## REVIEW OF GROUND ISSUES

<b>Job No.</b>	3435	<b>Site area/ha</b>	8.3	
<b>Client:</b>	Harron Homes	<b>NGR:</b>	SE 174 173	
<b>Site:</b>	Crossley Lane, Dalton	<b>Nearest postcode:</b>	HD5 0QP

**Introduction.** It is understood that Harron Homes are considering acquisition of land at Crossley Lane, Dalton with a view to redevelopment with housing. Harron have provided Lithos with copies of the following:

EXPLORATORY HOLE LOCATIONS

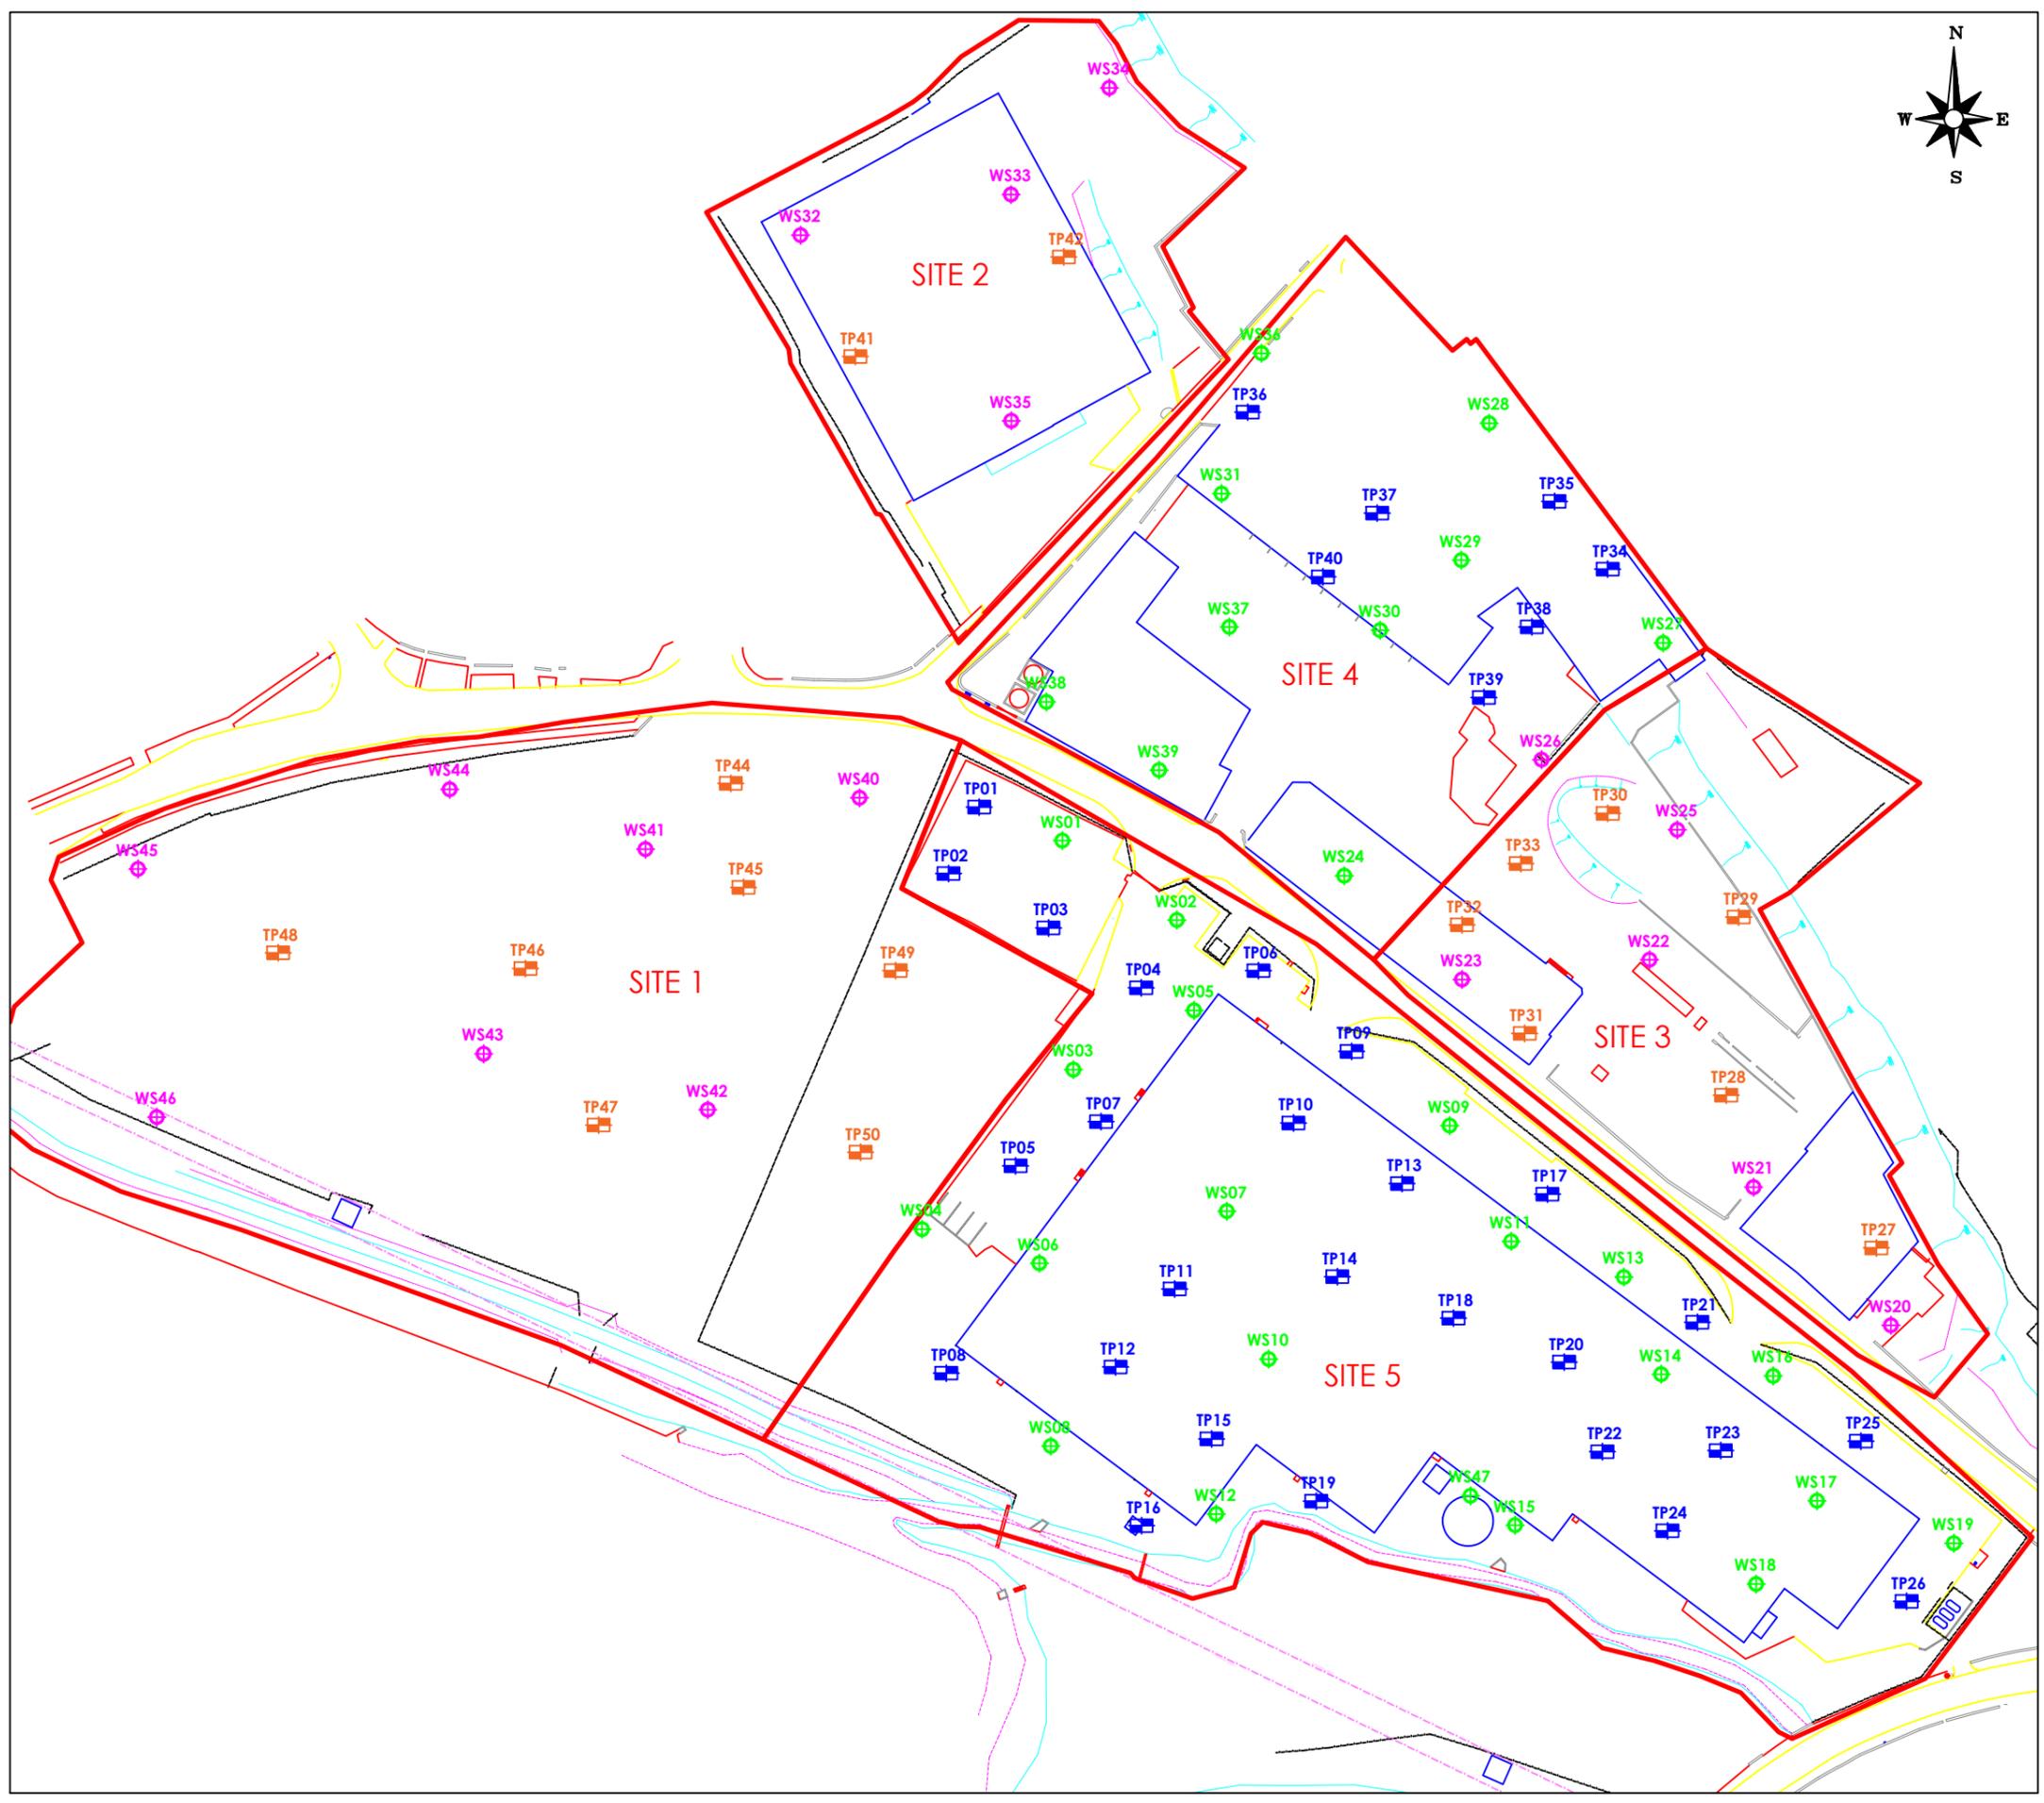
The boundaries of Sites 1 to 5 are shown on Lithos Drawing 3435/6 appended to this report.

Mining & Quarrying	<p><b>Coal:</b> Shallowest coal c. 100m (Hard Bed). No significant risks identified.</p> <p><b>Elland Flags:</b> Risks of Elland Flags mining are not mentioned by ARP. The west of the site (Site 1) is underlain by Elland Flags Sandstone. However, no quarries are shown on historical plans on site, nor within the local area. The nearest known former Elland Flags mine is at Fixby, some 6km north-west, and the Elland Flags are overlain by alluvium (according to BGS plans). Therefore, risks of workings beneath the site are considered very low and do no warrant further assessment.</p> <p><b>Quarries:</b> None within the vicinity of the site.</p>
Ground Investigations	<p>Have been undertaken by:</p> <p><b>Sirius</b> (2006). This included boreholes, trial pits and WSs across the site. ARP's Report 1 (for Sites 1 to 3) includes Sirius' lab testing results and comments are made regarding ground conditions encountered by Sirius. However, Sirius' logs are not included in ARP's report and Lithos do not have a copy of Sirius' report. In Report 2 (for Sites 4 and 5), ARP do not appear to use any of Sirius' lab testing results.</p> <p><b>ARP</b> (2016): This GI included: 48 trial pits and 48 window-sample boreholes. All exploratory hole locations are shown on Drawing 3435/6. Further comments below.</p>
